APPLICATION NO.	FILING DATE	FIRST NAMED INVENTOR	ATTORNEY DOCKET NO.	CONFIRMATION NO.
09/617,749	07/17/2000	Jerry McKinney	Clearstrm-6	8682

Office Action Summary	Application No. 09/617,749	Applicant(s) MCKINNEY, JERRY	
	Examiner Chester T. Barry	Art Unit 1724

35 U.S.C. §103(a) Obviousness over McKinney '470 and Adams '459

Fig. 1 (SIDE VIEW)

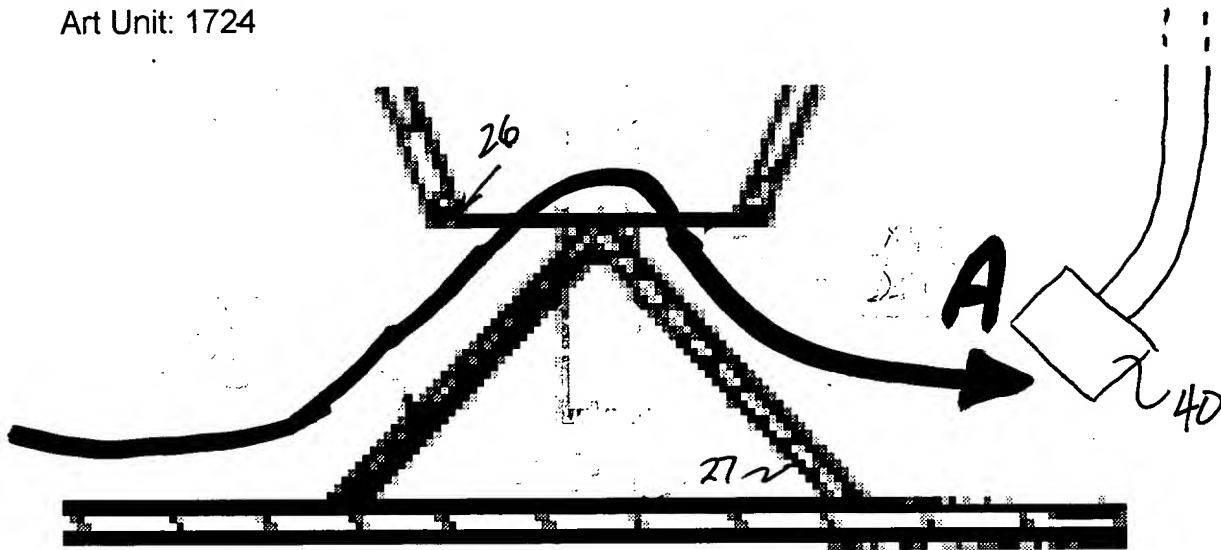
along the opposite side wall to the bottom, and sixth and seventh components that flow in opposite directions adjacent the bottom wall of the vessel is induced by the aeration gas flow. The aeration system provides sufficient oxygenation gas to allow the aerobic bacteria to digest the organic solids in the wastewater. It is unclear if the current pattern induced by the aeration gas flowing through only one of the two diffusers has a fifth component that flows across the bottom under the opening to the clarifier chamber. That is, it is unclear if a current component rises up over a portion of the deflector 27 underlying clarifier opening 26 and back down the opposite side of the deflector towards the solitary operational diffusers without being swept up into the clarifier proper given the hydraulic driving force present at times when wastewater is actually flowing¹⁴ into the treatment plant through inlet 24. Furthermore, it is unclear during periods of no wastewater influx whether currents flowing across the bottom wall would rise up over at least a portion of the deflector underlying the clarifier opening, as shown by arrow "A" in Fig. 1 *infra*, or if the "cross-flow" would simply separate laterally into two branches "B" at the intersection of the deflector and the bottom wall, as shown by arrows "B" in Fig. 2 *infra* (without any split flow lying underneath clarifier opening 26).

(emphasis added). Applicant, therefore, admitted that provision of a pyramid shaped deflector plant in this type of prior art treatment plant, such as that exemplified by the McKinney '470 patent, was merely optional. It would have been obvious, therefore, for the skilled artisan to have omitted from the McKinney '470 treatment plant the deflector in view of the recognition in this art, as shown by applicant's admission, that such deflectors were merely optional.

Fig. 3

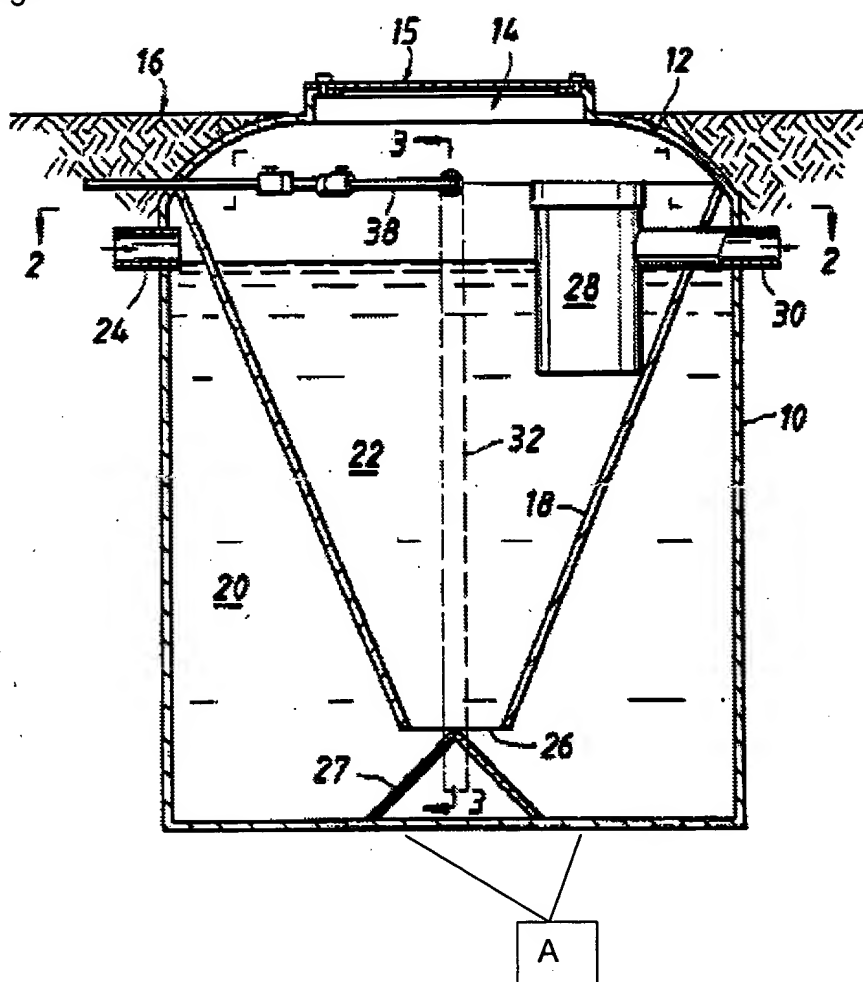
¹² While McKinney '470 does not describe a substantially flat bottom wetted surface by virtue of the conic-shaped wetted surface of the deflector, a substantially flat bottom wall of the vessel is clearly shown. It is on this substantially flat bottom wall that the deflector is attached. See Fig. 3. *infra* ("A").
